DRB Application No.: 10DRB-70095 Project # 1008137  
Project Name: Westgate Heights Subd.  
Agent: DSA Architects LLC Phone No.: 342-6200

**FILE: Project 1008137  
10EPC-40004 Amended Site Development Plan for Building Permit**

**Re:** Project #1008137, 10EPC-40004, Site Development Plan for Building Permit Amendment

Sheet No. L-100

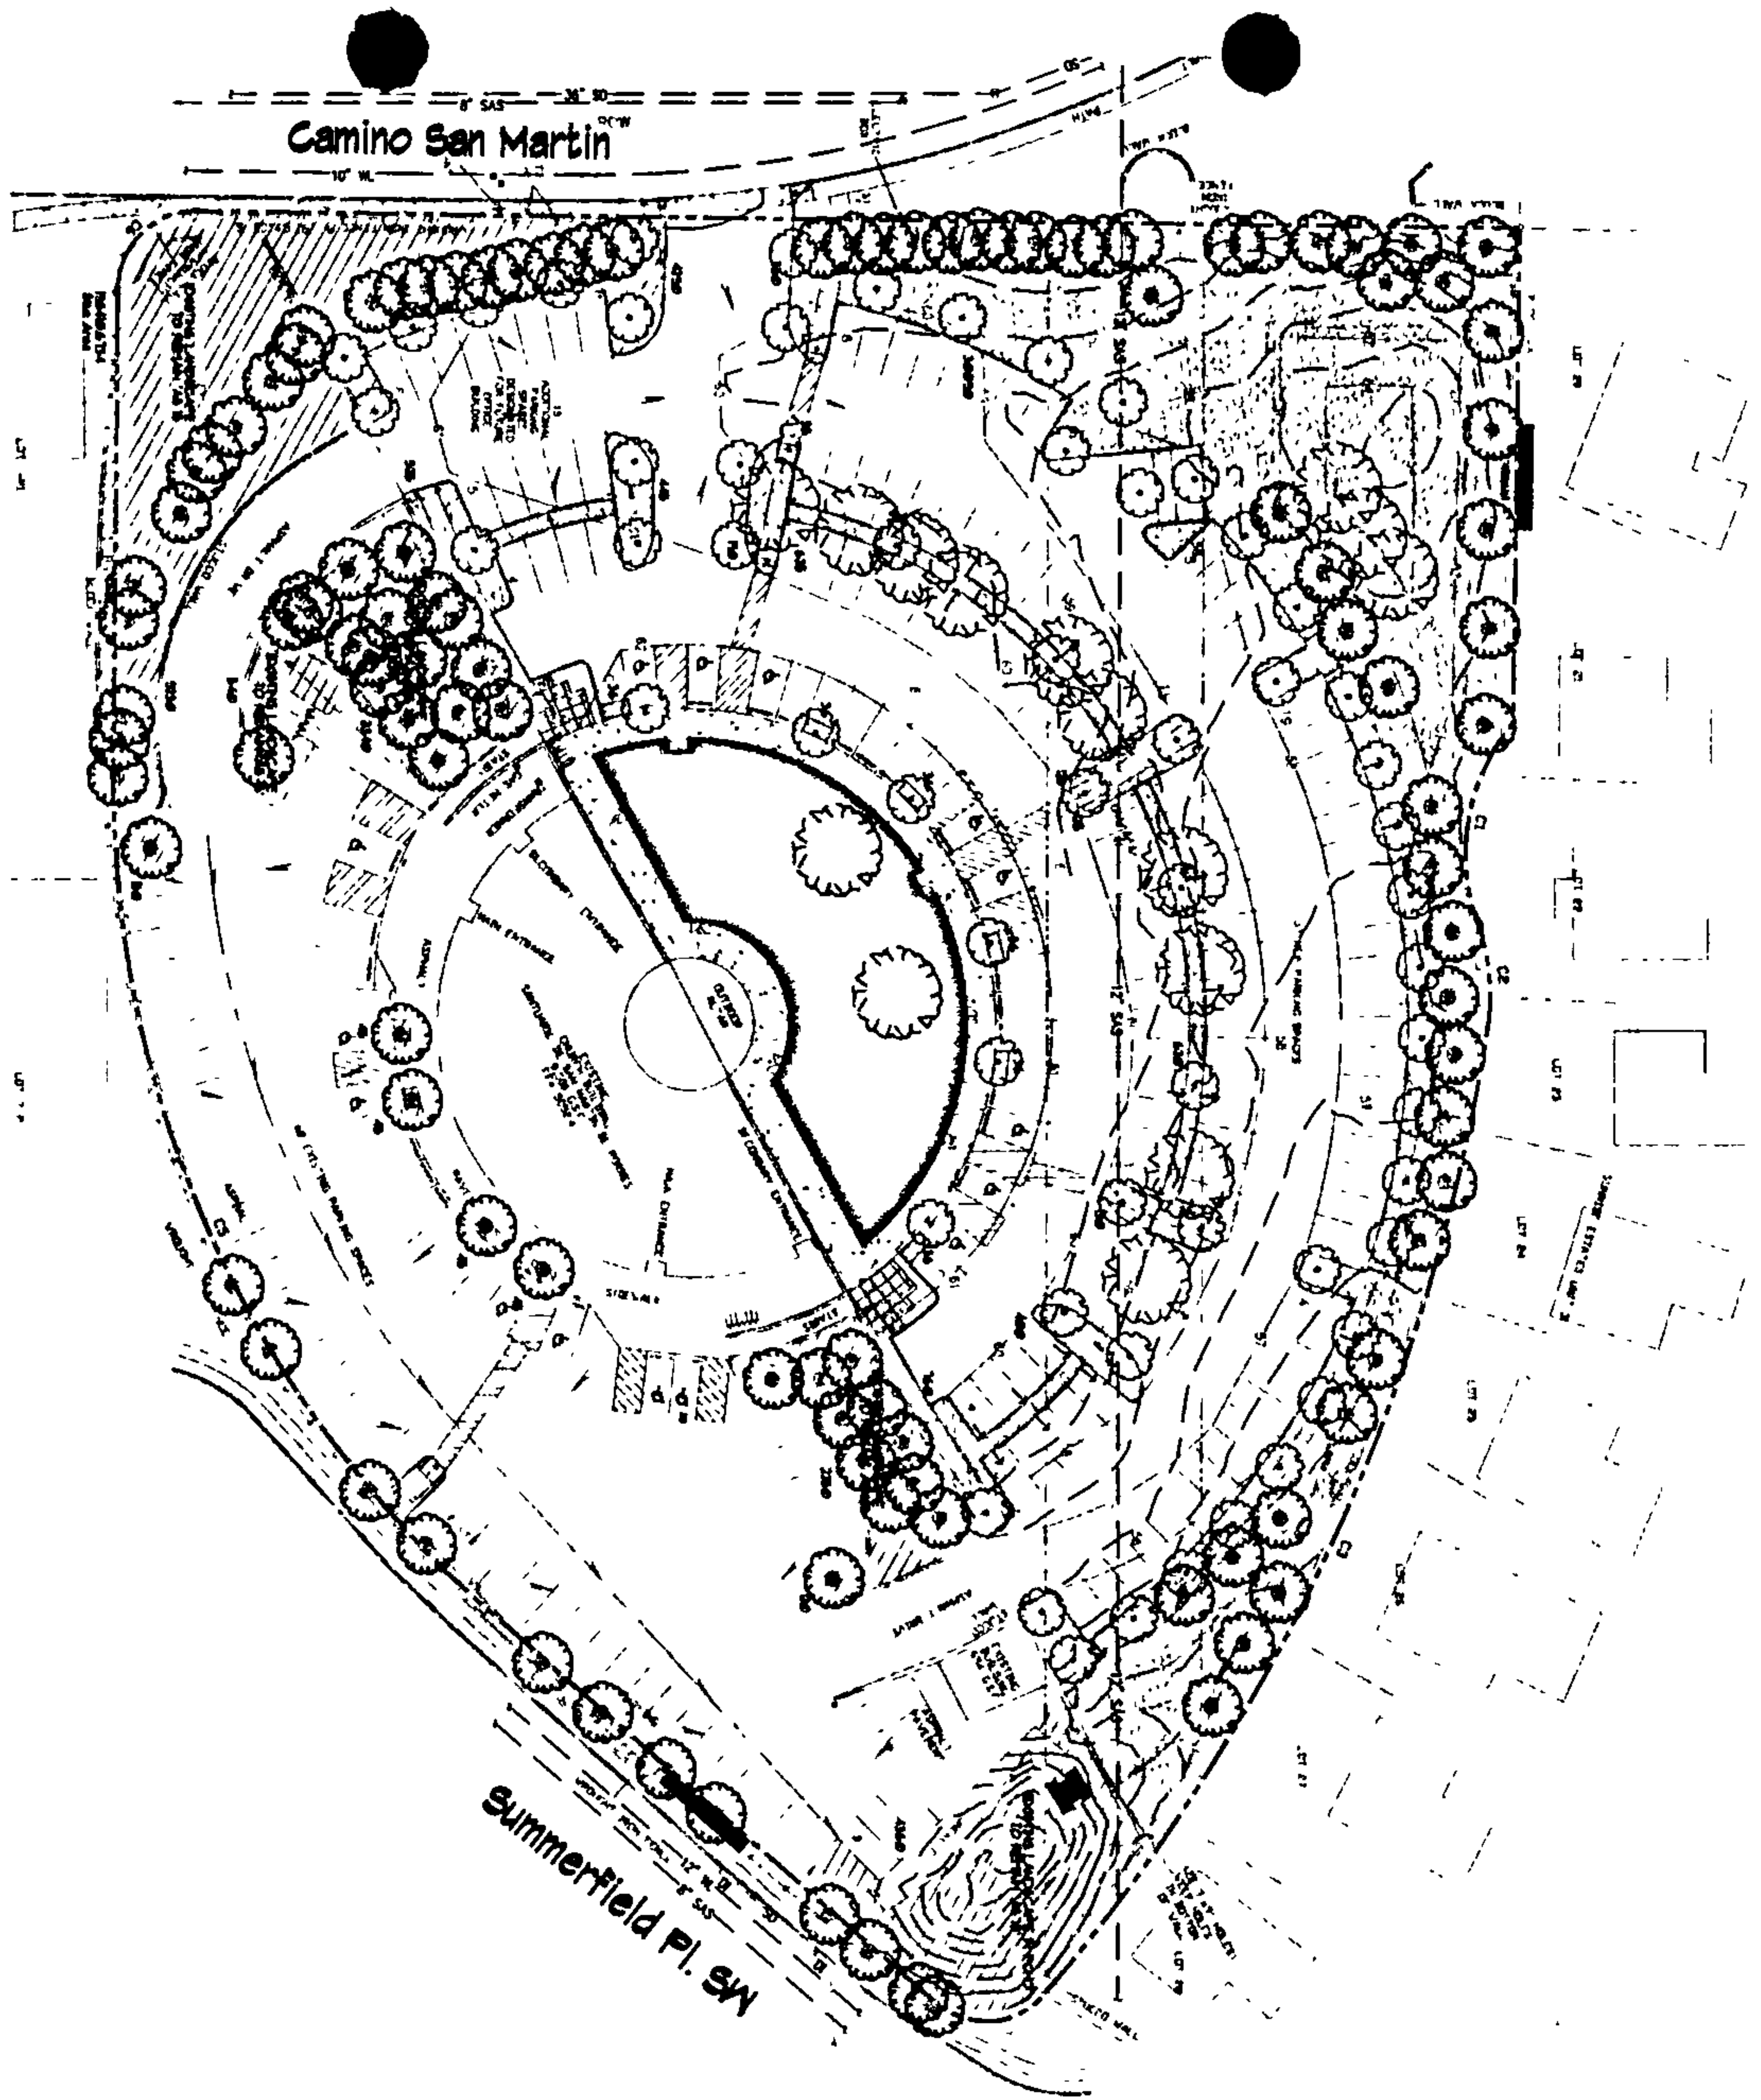
- a. The area of existing landscaping to remain "as is" in the north part of the site shall be hatched and its square footage shall be indicated on the site plan.
- b. Correct parking area tree calculations to reflect the actual number of parking spaces and trees provided.
- c. Improve the legibility of the note concerning the 30' clear zone in the SAS easement. Relocate the Honey Locust in the northeast corner of the site outside this zone.
- d. In landscape calculations, clarify which areas are included in the "total proposed" and "total existing" landscape provided.
- e. Ensure that square footage figures denoting the same landscaped areas are identical throughout the landscape plan.
- f. Add calculations for the Phase II development (future office building).

- d. Building mounted lighted has been added to sheet A-201.
9. Landscaping
- a. Existing landscaping on the north part of the site has been hatched.
  - b. Parking area tree calculations have been corrected.

- c. The SAS easement note has been enlarged.
  - d. Landscaping calculations have been revised and clarified.
  - e. Square footage figures are consistent throughout the submittal.

- f. Calculations for Phase II have been added.
10. Outdoor Amenities:
- a. Seating has been added along the circular frontage of the fellowship hall.
  - b. Two patio areas have been added with seating and shade trees.

PRELIMINARY GRADING PLAN  
1" = 20'

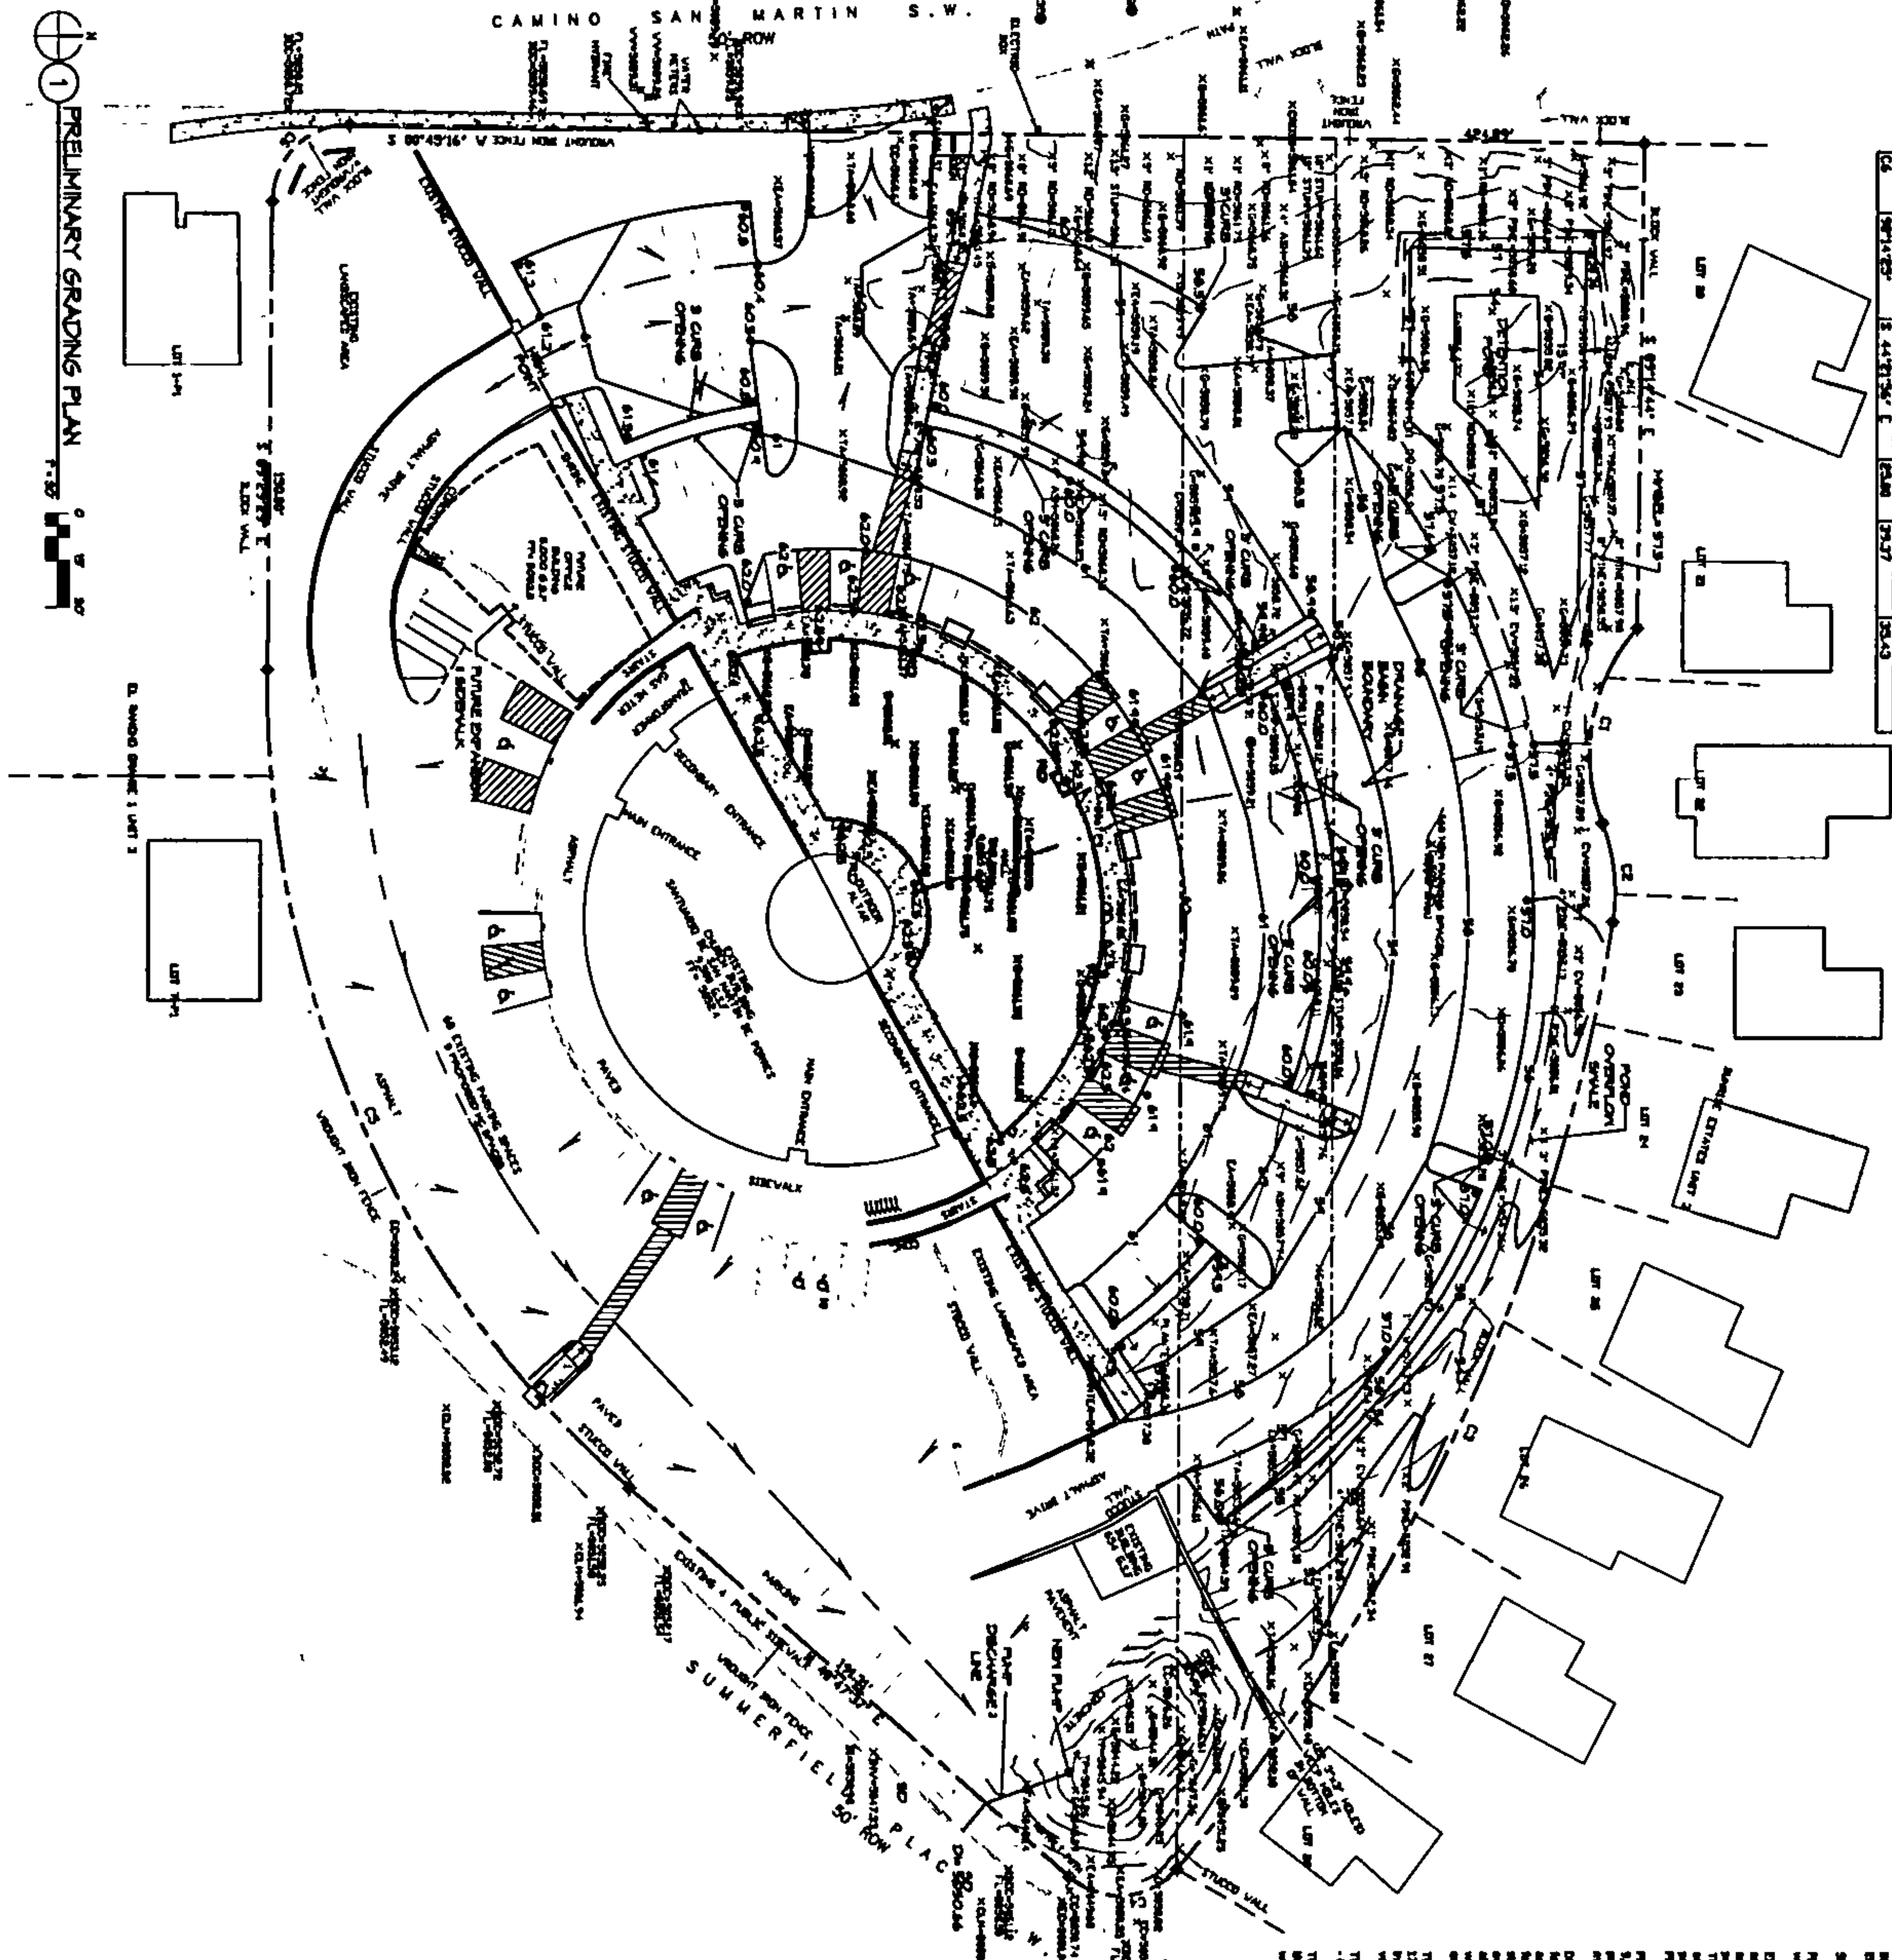
- a. Call out the square footage and finished floor elevation of the fellowship hall on the building footprint.
- b. Provide preliminary drainage information for the Phase II development (future office building).

- a. Finished floor elevations have been added
- b. Preliminary drainage information for Phase II has been added.
